Re: Taxiway and Access Road Improvements  
Miller Municipal Airport  
Miller, South Dakota  
AIP #3-46-0035-016-2025  
Helms #A-8967

**ADDENDUM NUMBER 1**

**ADDENDUM NO. 1**

2. REPLACE the following plan sheets with the attached: E1, E4, E6, E7.
3. ADD the following new plan sheets which are attached: E106, and E107.

**BID ALTERNATE 1, 2, & 3**

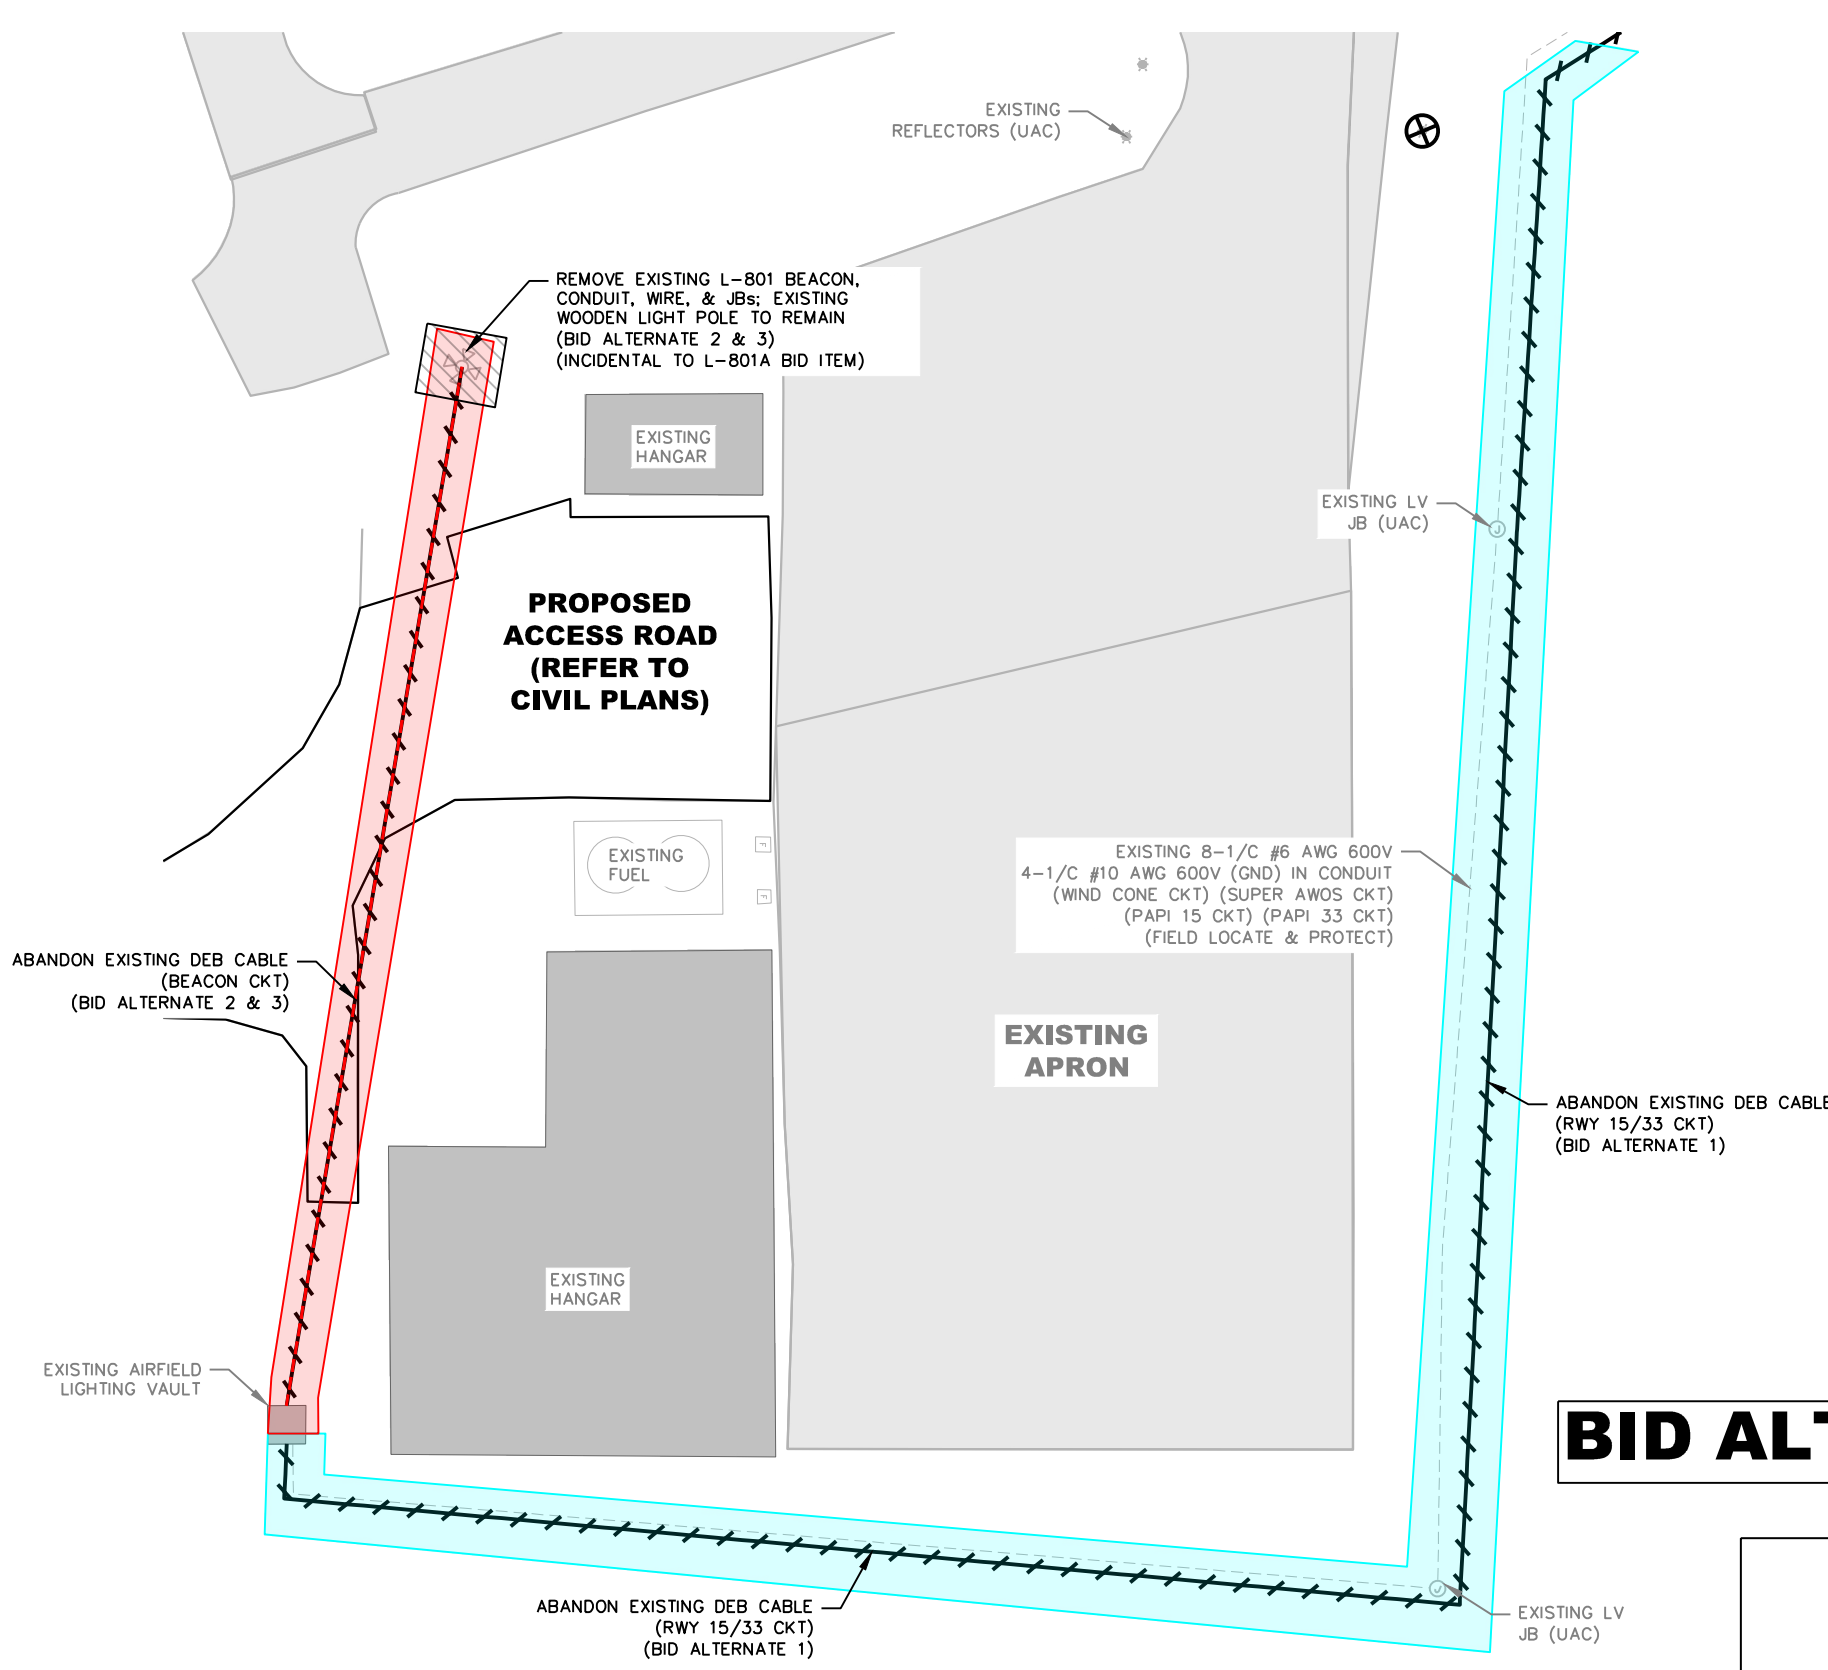
**BID ALTERNATE 2**

- REMOVE EXISTING BEACON, CONDUIT & JBs. LIGHT POLE & FIXTURE TO REMAIN.
- SHALL INCLUDE A NEW L-801A LED BEACON, CLASS 2 W/ BIRD SPIKES INSTALLED ON EXISTING WOOD LIGHT POLE.
- WORK SHALL ALSO INCLUDE ABANDONMENT OF THE EXISTING BEACON CIRCUIT AND INSTALLATION OF NEW CONDUIT AND CABLE(S) FROM THE VAULT TO THE NEW BEACON INCLUDING UP THE EXISTING WOOD LIGHT POLE.

**BID ALTERNATE 3**

- REMOVE EXISTING BEACON, CONDUIT & JBs. LIGHT POLE & FIXTURE TO REMAIN.
- SHALL INCLUDE A NEW L-801A LED BEACON, CLASS 2 W/ BIRD SPIKES INSTALLED ON A NEW 40-FOOT TIP-DOWN POLE INCLUDING CONCRETE FOOTING.
- WORK SHALL ALSO INCLUDE ABANDONMENT OF THE EXISTING BEACON CIRCUIT AND INSTALLATION OF NEW CONDUIT AND CABLE(S) FROM THE VAULT TO THE NEW BEACON.

Sheet  
E4

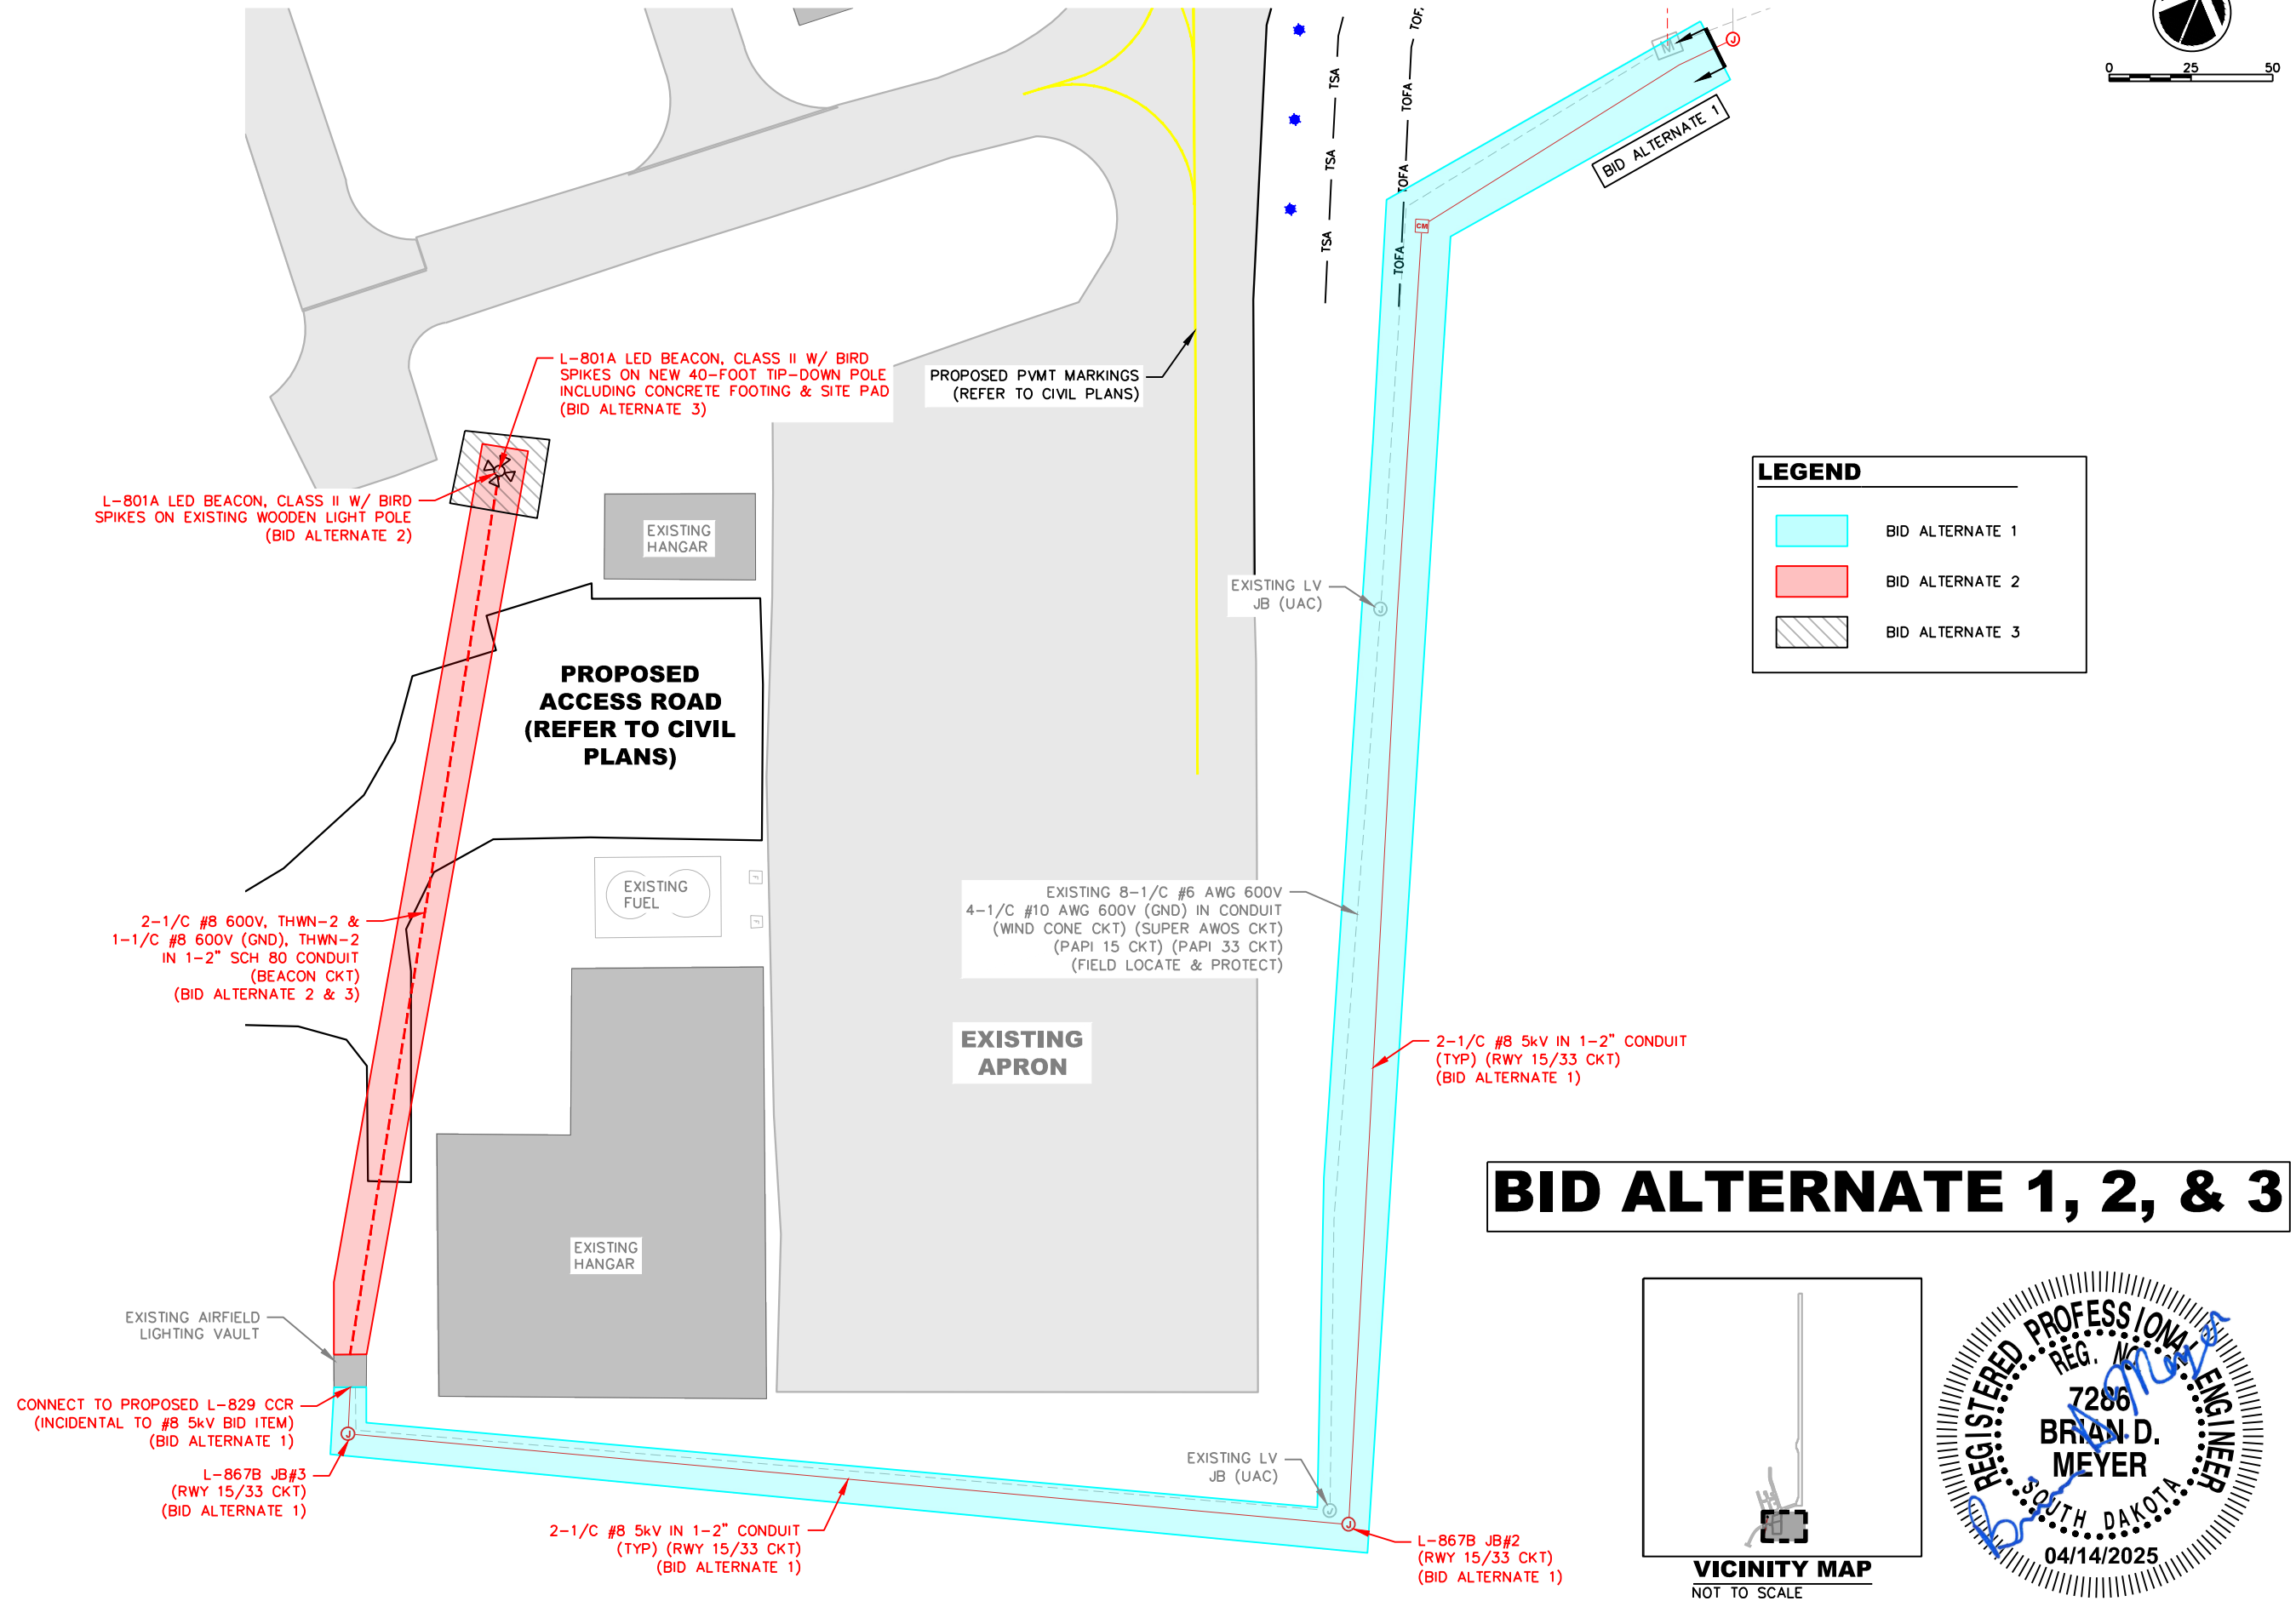
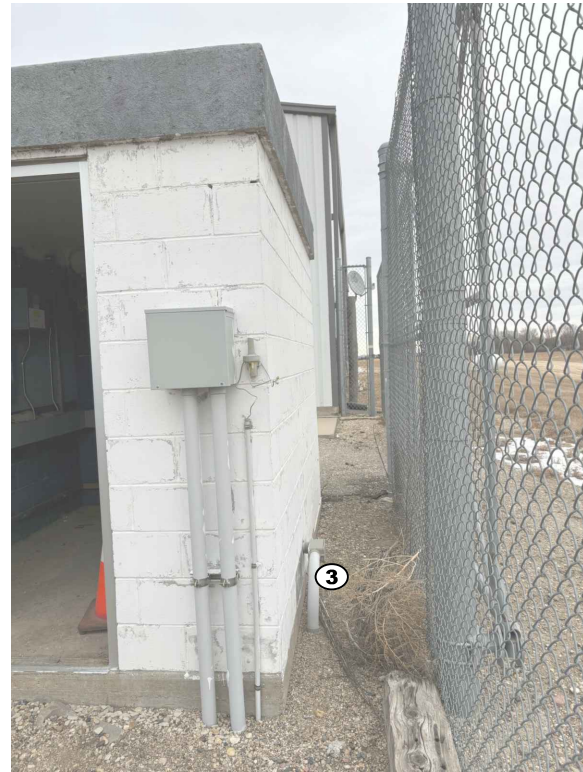
**EXTERIOR NORTH WALL OF VAULT BLDG (UAC) (BID ALTERNATE 2 & 3)**  
NOT TO SCALE

**PROPOSED PANEL P1 (VAULT BUILDING) - 120/240 V GE LOAD CENTER, CAT. NO. 252B3168P42**

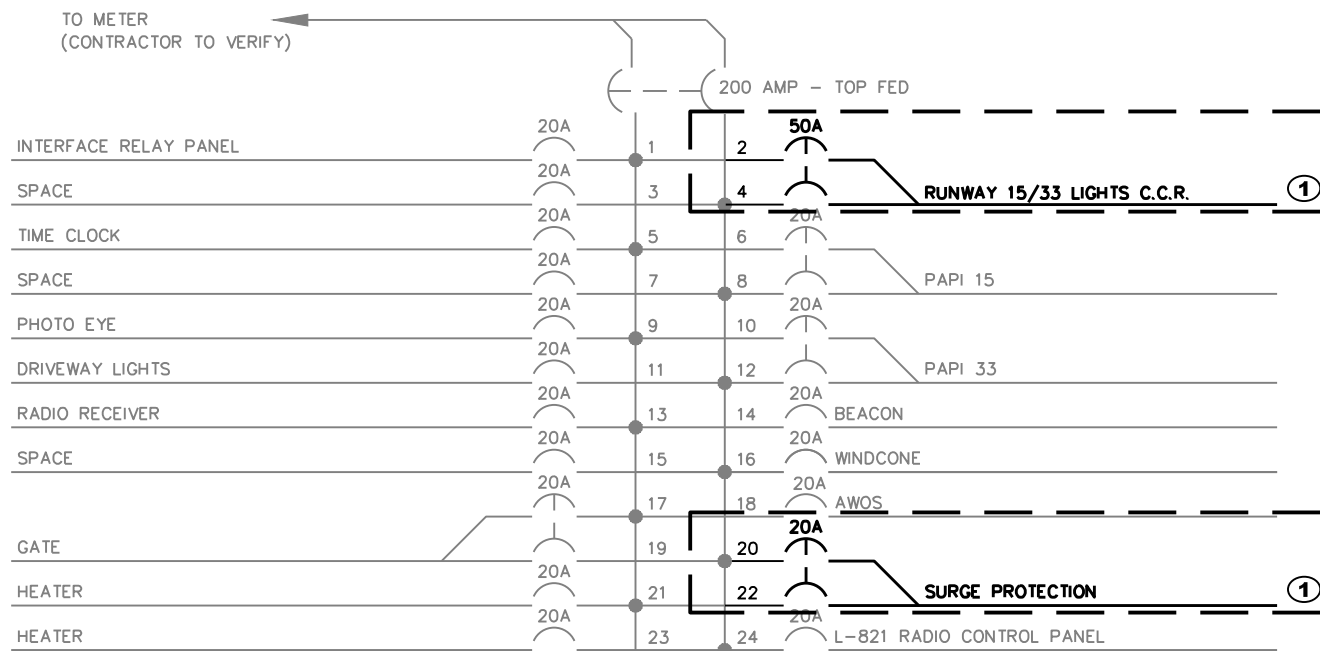
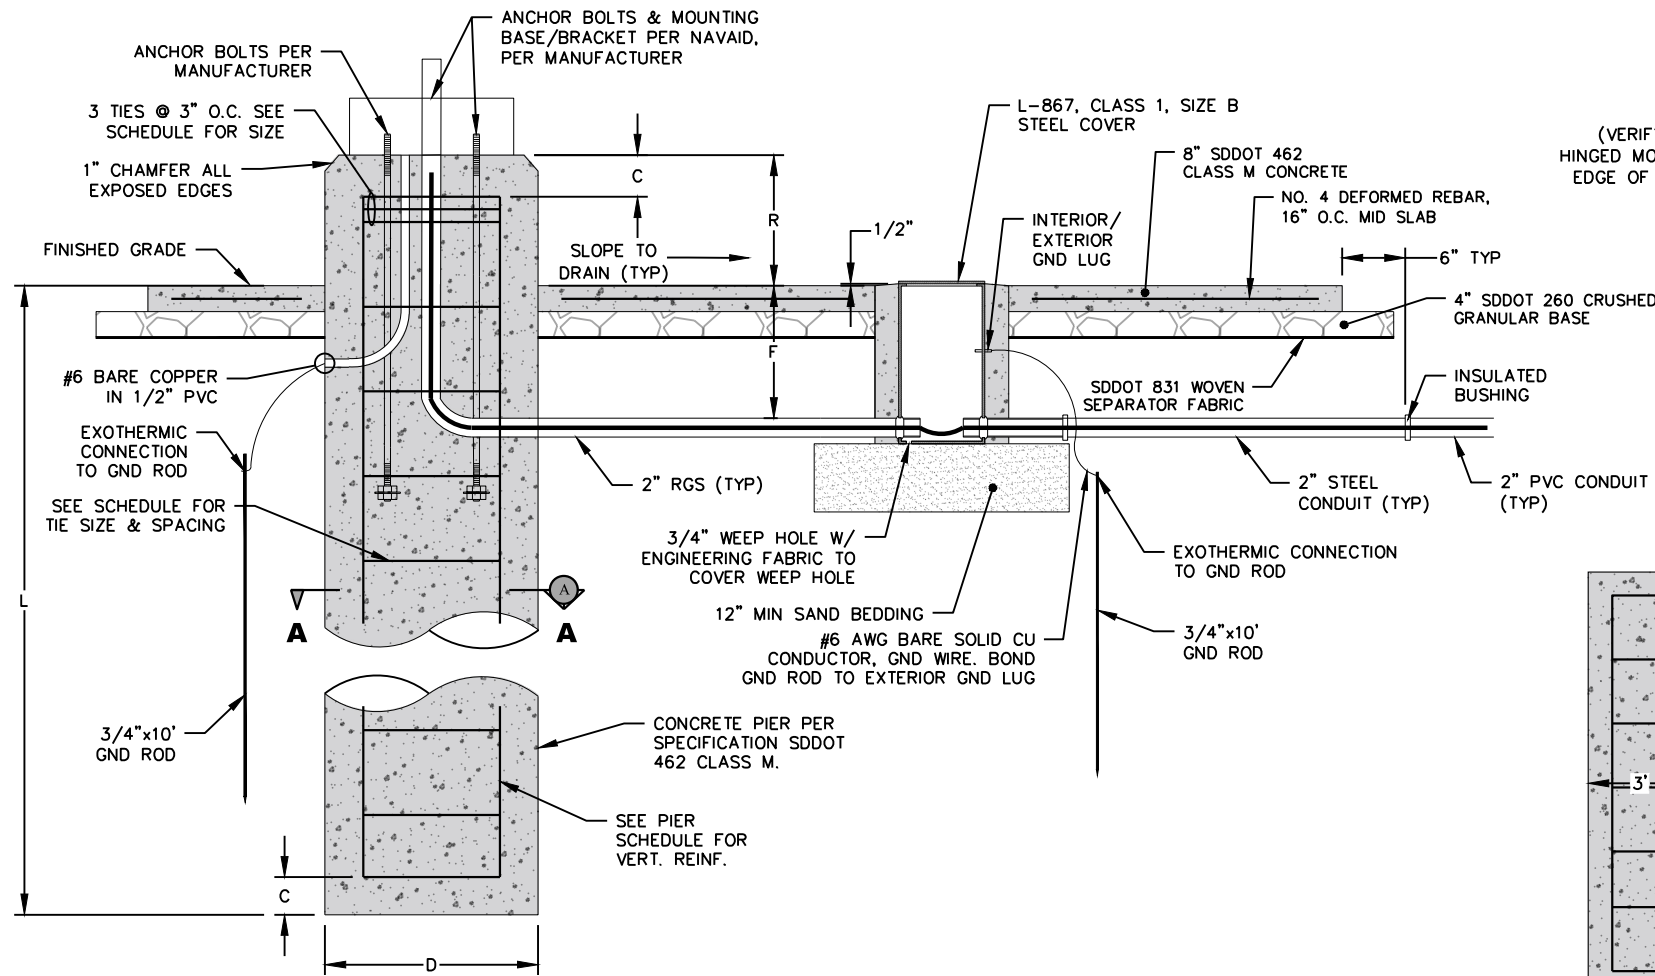
- ① SIZE BREAKER & CIRCUIT PER SUPPLIED EQUIPMENT.
- ② REMOVE & SALVAGE TO OWNER EXISTING L-828, 4kW CCR. REMOVE & DISPOSE OF CONDUIT CONNECTIONS TO WIREWAY.
- ③ FIELD LOCATE & CONNECT VAULT ENTRY CONDUIT (BID ALTERNATE 1) FOR RWY 15/33 CKT.
- ④ INSTALL L-829 CCR (REGULATOR W/ MONITORING), CLASS 1 (6.6A), STYLE 1 (3-BRIGHTNESS STEPS), SIZE 5 kW. PROVIDE NEW CONDUITS TO WIREWAY.
- ⑤ INSTALL SURGE PROTECTION DEVICE & CONNECT TO EXISTING PANEL P1. ALSO SEE SPECIFICATION L-190.
- ⑥ REUSE EXISTING BEACON CONDUIT (BID ALTERNATE 2 & 3).
